HISTORIC AND DESIGN REVIEW COMMISSION

Agenda Item No: 28

HDRC CASE NO: 2016-306
ADDRESS: 510 PASCHAL
LEGAL DESCRIPTION: NCB 1737 BLK 6 LOT 8 (CARLA HILLS)
ZONING: MF33 H
CITY COUNCIL DIST.: 1
DISTRICT: Tobin Hill Historic District
APPLICANT: Carlos McDermott
OWNER: Carlos McDermott
TYPE OF WORK: Construct new driveway
REQUEST:

The applicant is requesting a Certificate of Appropriateness for approval to install new 10' wide decomposed granite driveway with concrete approach.

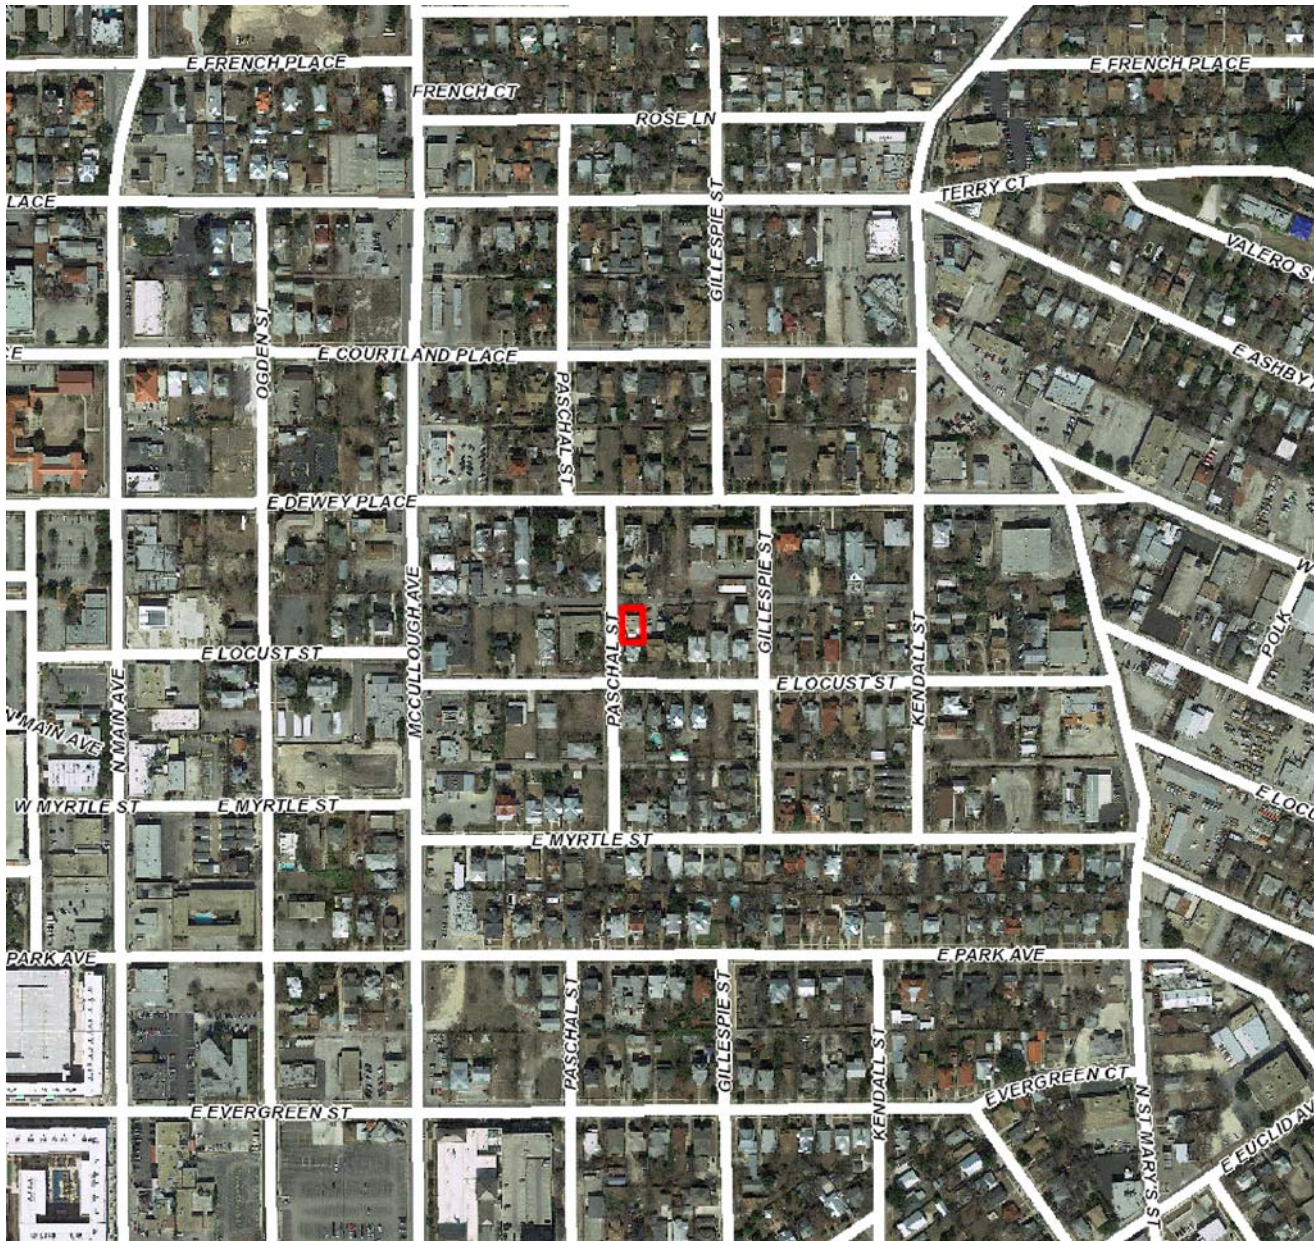
- a. The home at 510 Paschal is in the Tobin Hill Historic District, which was designated March 16, 2008.
- b. There is an existing front facing attached garage and a 20' concrete driveway. There is an existing front and side lawn with a concrete paver front walkway and a secondary concrete walkway to a secondary entrance. The applicant is proposing to install a 10' wide decomposed granite driveway on the left of the existing home over the existing left side lawn. According to the Guideline for Site Elements, Section 3 and 5, historic lawns should not be reduced more than 50% and historic driveway configurations and patterns should be retained and incorporated.

Staff finds the additional driveway not consistent with the Guidelines because two front driveways for a single residence is not similar or compatible with the established pattern in the district.

Staff recommends denial based on findings a and b.
